**CODE CONSULTANTS
PROFESSIONAL ENGINEERS, PC**

**RE: APRIL 12, 2006 MEETING
WTC MEMORIAL AND MEMORIAL MUSEUM
PROJECT NOS. 7383-4 & 7966-4**

RE: FIRE SIMULATION STUDIES
WTC MEMORIAL AND MEMORIAL MUSEUM
PROJECT NOS. 7383-4 & 7966-4

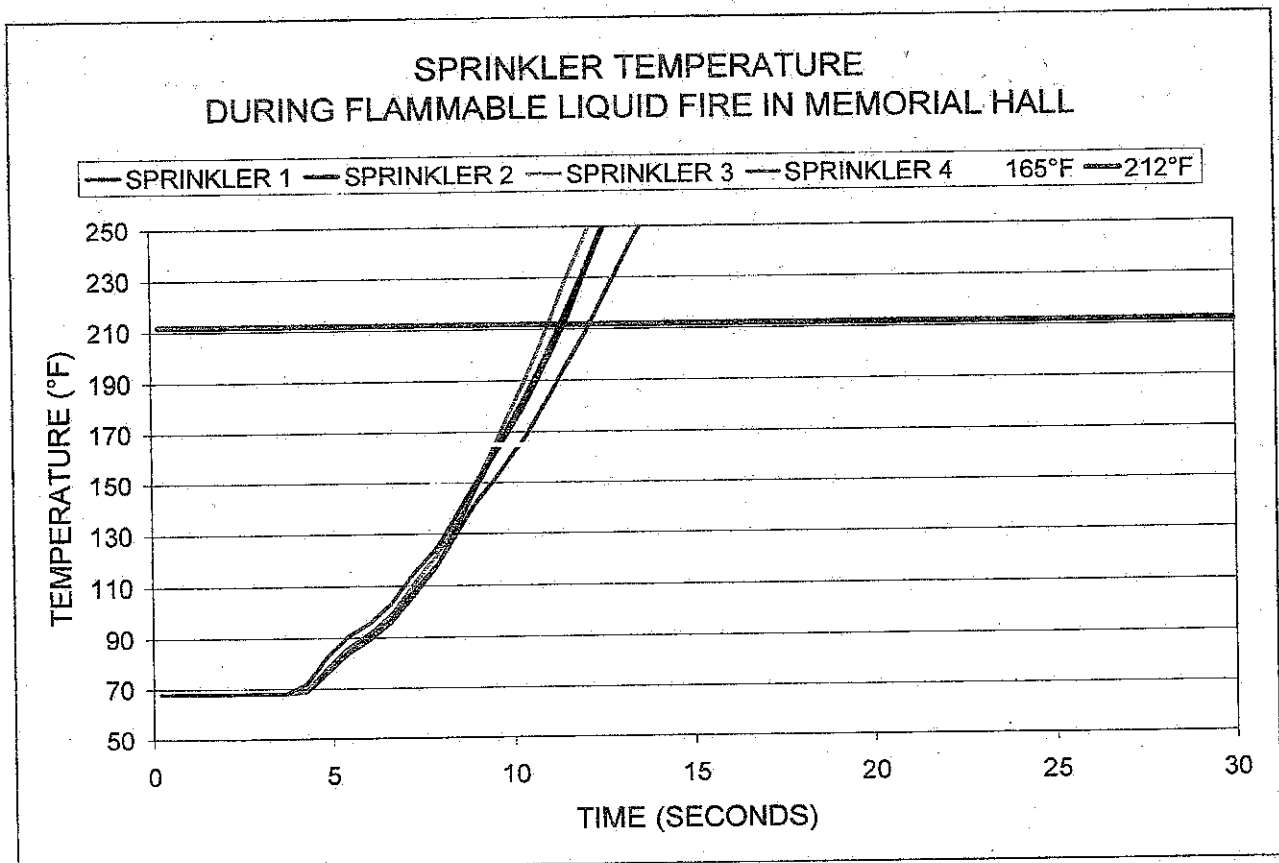
4. *Provide information of tenable condition parameters such as heat and smoke density for the slice where air is drawn into floors below +284.*

The following table illustrates the air flow into the floors below the +284'-0" level during a flammable liquid fire in Memorial Hall. The figures show a section of the Memorial pools, where airflow is indicated using velocity vectors. In the first figure, the velocity vectors are shaded to indicate the velocity of the flow. In the second figure the velocity vectors are shaded to indicate the temperature of the air.

The air flow entering the levels below +284'-0" is induced by the waterfall, the effects of which were included in the CFD model for the Memorial. Thus, the air entering the level below +284'-0" is fresh, outside air. Note that the temperature of the air passing into the opening is at ambient temperature (70°F) indicating that smoke or products of combustion are not present.
